UNITED STATES PATENT AND TRADEMARK OFFICE

APPLICATION NO.	FILING DATE	FIRST NAMED INVENTOR	ATTORNEY DOCKET NO.	CONFIRMATION NO.
10/607,603	06/27/2003	Curtis A. Richardson	89190.022103/DP309242	7612
22851	7590	09/15/2005	EXAMINER	
DELPHI TECHNOLOGIES, INC.			ALEJANDRO, RAYMOND	
M/C 480-410-202			ART UNIT	
PO BOX 5052			PAPER NUMBER	
TROY, MI 48007			1745

Office Action Summary

DETAILED ACTION

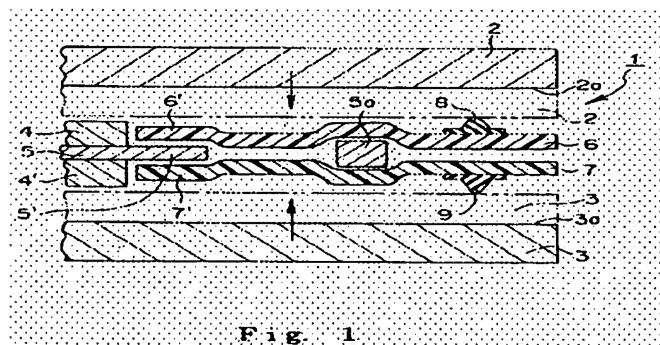
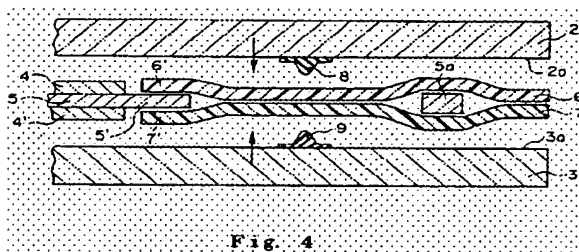
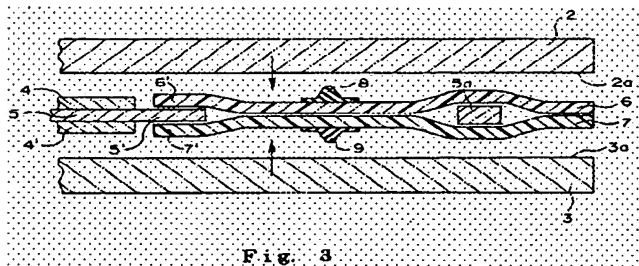
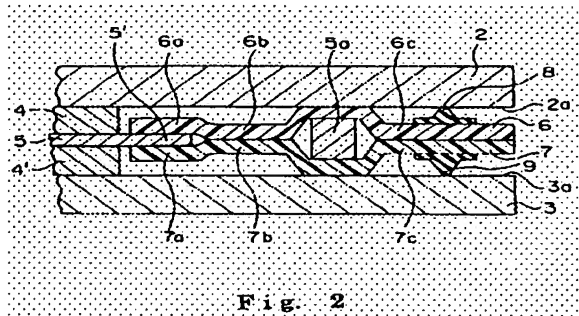
Figures 1-4 below depict the specific structure of the gasket body formed by sheets 6 and 7 and comprising planar and non-planar regions. As evident from Figure 2 below, spacer 5a is inserted between gasket sheets 6 and 7 and an empty space is formed therebetween. *That empty space is considered to constitute an air hole.* Thus, the gaskets also form the gas-filled pillow structure for sealing the joint therebetween.

As evident from FIGURES 1-4 above, the gasket sheets includes a concavity structure (See FIGURES 1-4).
